Croft Medical Centre – Response to Highways comments in relation to the proposed replacement Medical Centre (Ref: EG/57/16/PL)

1. This note sets out the comments made by West Sussex County Council (WSCC) in relation to the proposals to construct a replacement Medical Centre on the plot of land to the west of the existing facility in Eastergate.

SUBJECT: EG/57/16/PL

Swept Path Analysis Using a Large Refuse Vehicle

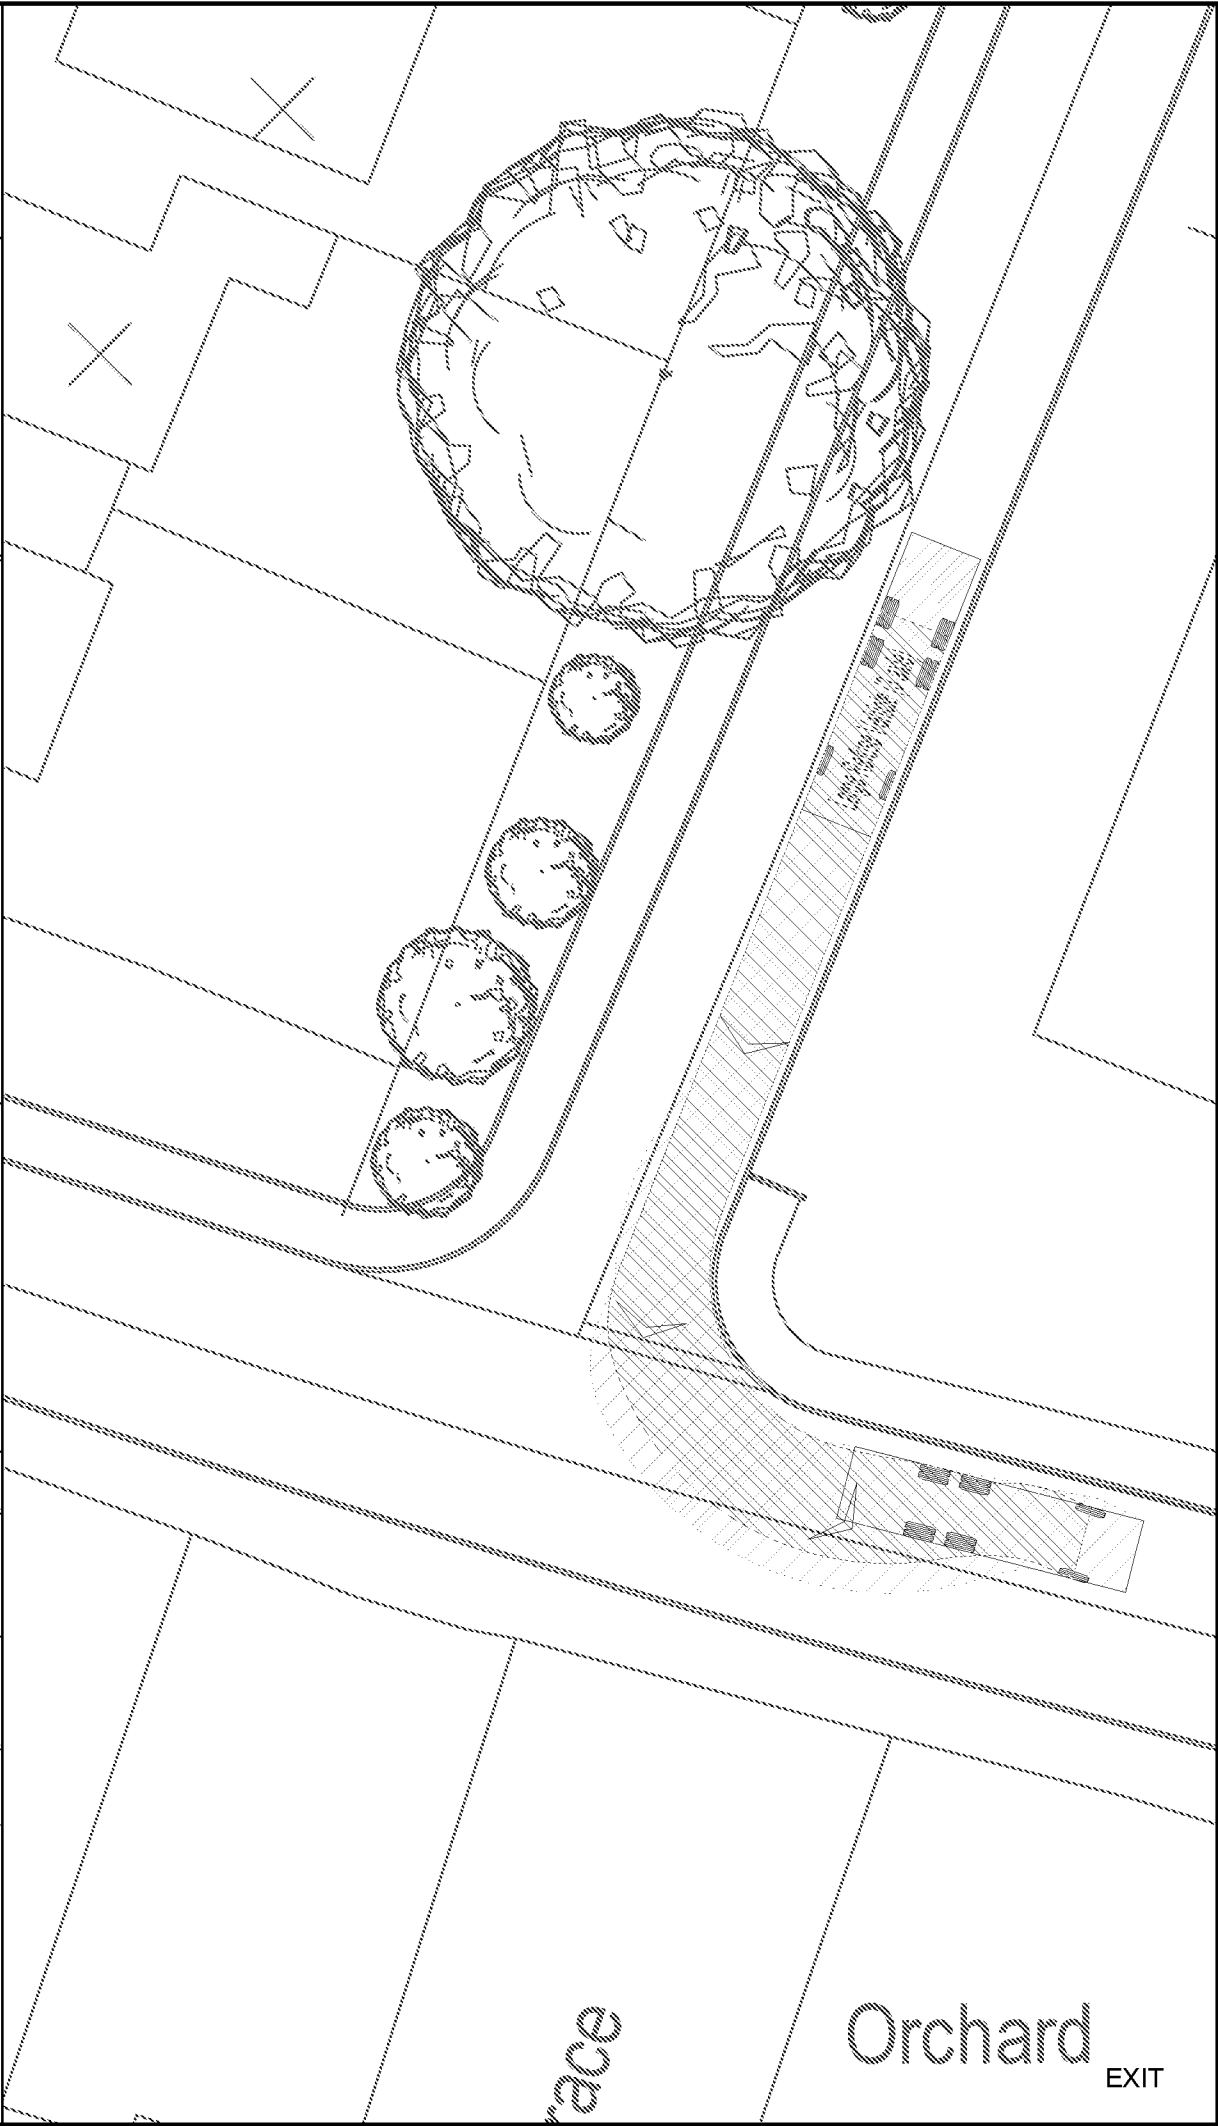
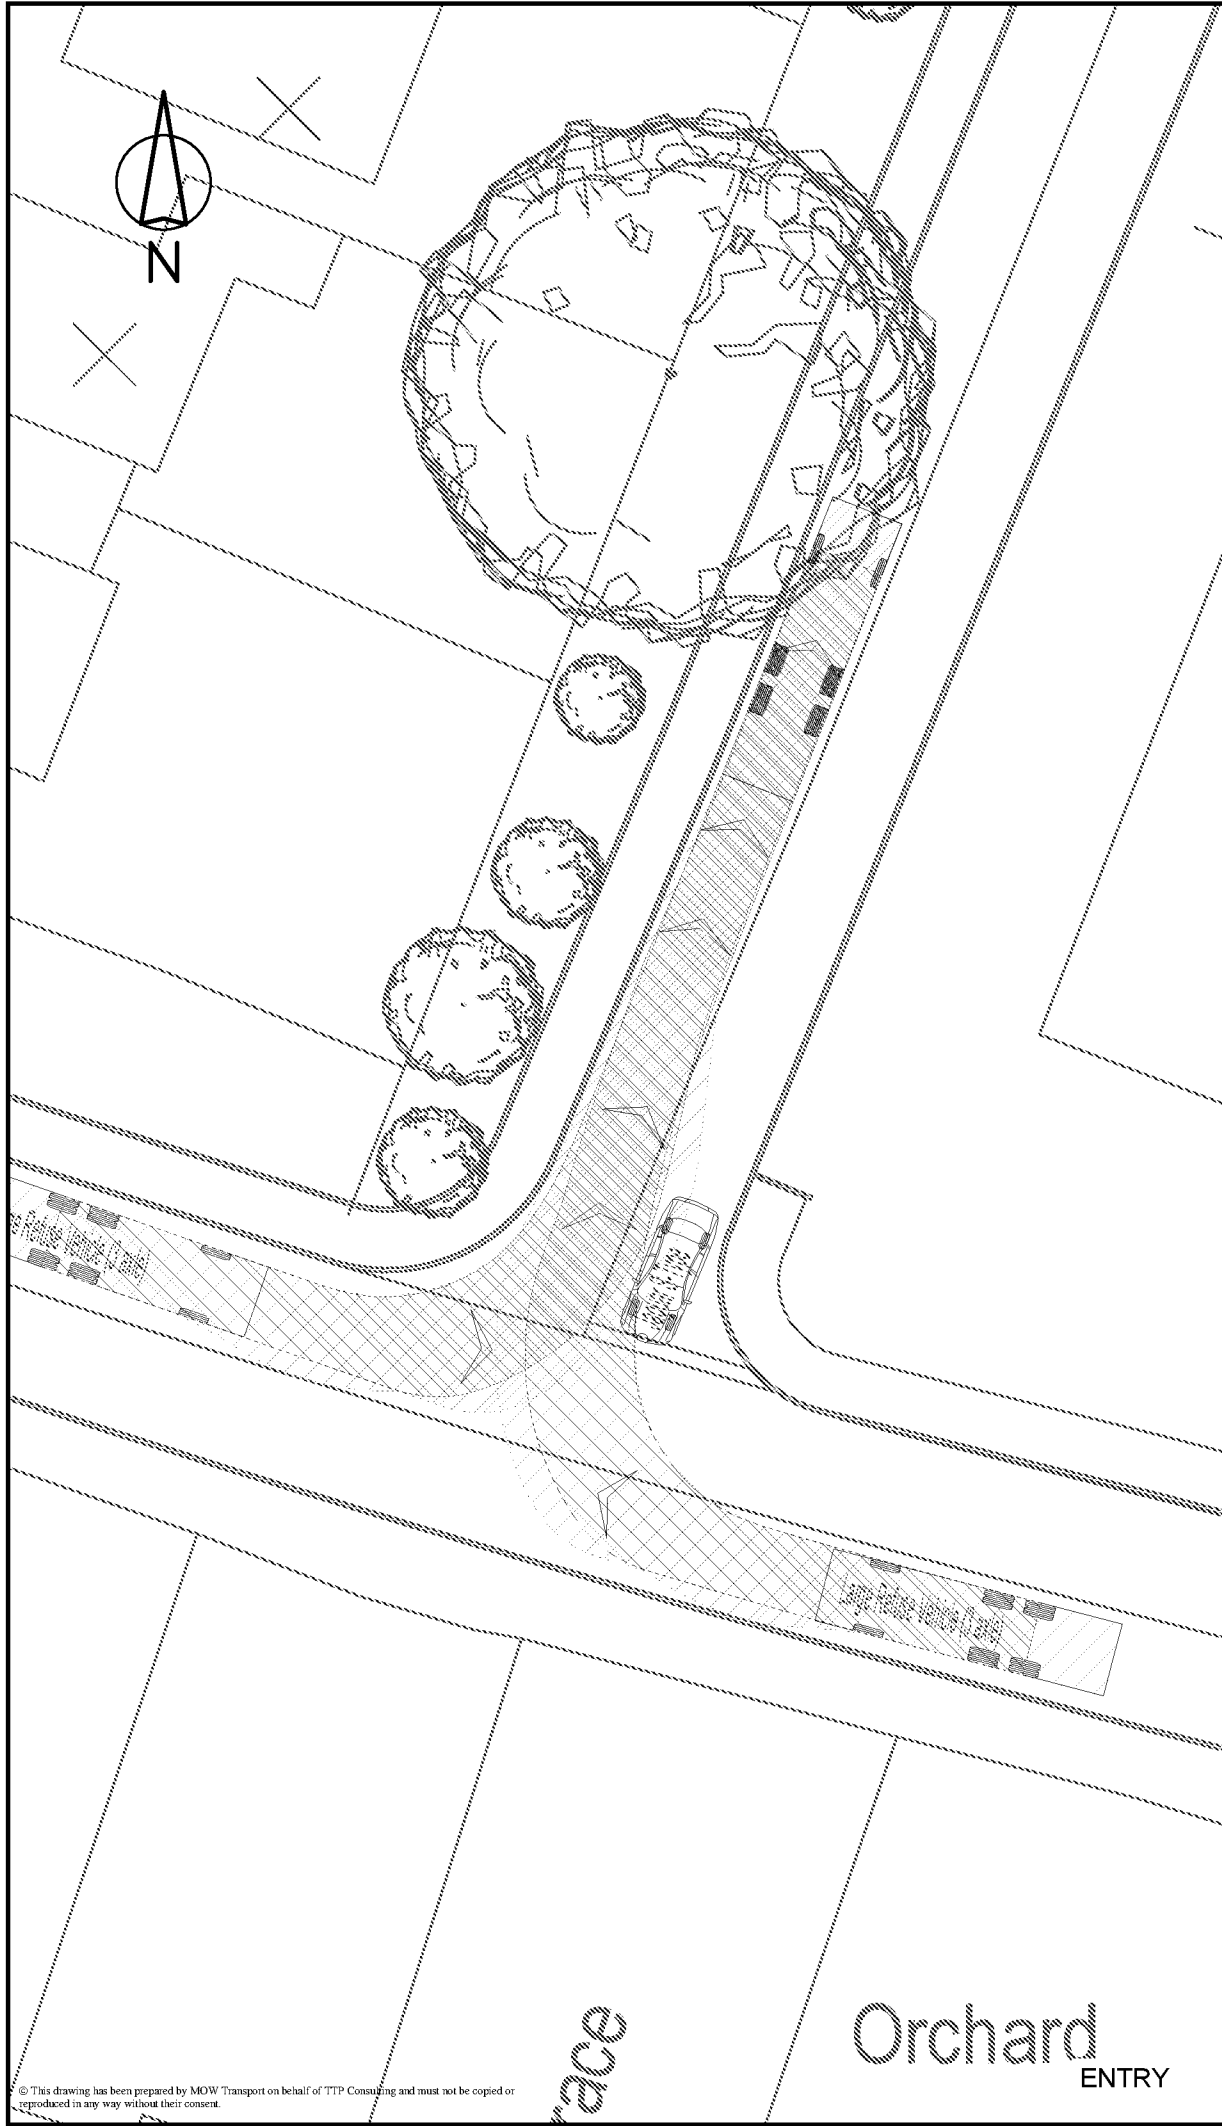
A dedicated turning head has been shown at the end of the access road. This appears small and there doesn't appear to be any barriers to stop parking occurring on the site access road in this location to make sure this area is kept clear for large vehicles to turn at all times.

It is also not clear what type of vehicle has been used on the tracking diagrams. The LHA would request that revised tracking is provided to demonstrate that a large refuse truck could turn on site to exit onto the highway in forward gear.

Tracking should also be provided to demonstrate that the proposed access off Barnham Road could accommodate two passing vehicles and a refuse truck entering and exiting the site safely.

essential users, and thus increase car parking capacity for patients. While cycle parking is to be provided, the provision of unrestricted car parking for staff would encourage car use and not promote the use of sustainable transport. This would conflict with current sustainable transport policies. The LHA would request that a Staff Travel Plan is submitted.	
Refuse/delivery vehicles A dedicated turning head has been shown at the end of the access road. This appears small and there doesn't appear to be any barriers to stop parking occurring on the site access road in this location to make sure this area is kept clear for large vehicles to turn at all times. It is also not clear what type of vehicle has been used on the tracking diagrams. The LHA would request that revised tracking is provided to demonstrate that a large refuse truck could turn on site to exit onto the highway in forward gear. Tracking should also be provided to demonstrate that the proposed access off Barnham Road could accommodate two passing vehicles and a refuse truck entering and exiting the site safely.	Swept paths of refuse vehicles entering, turning and exiting the site in forward gear are provided in Annex E.
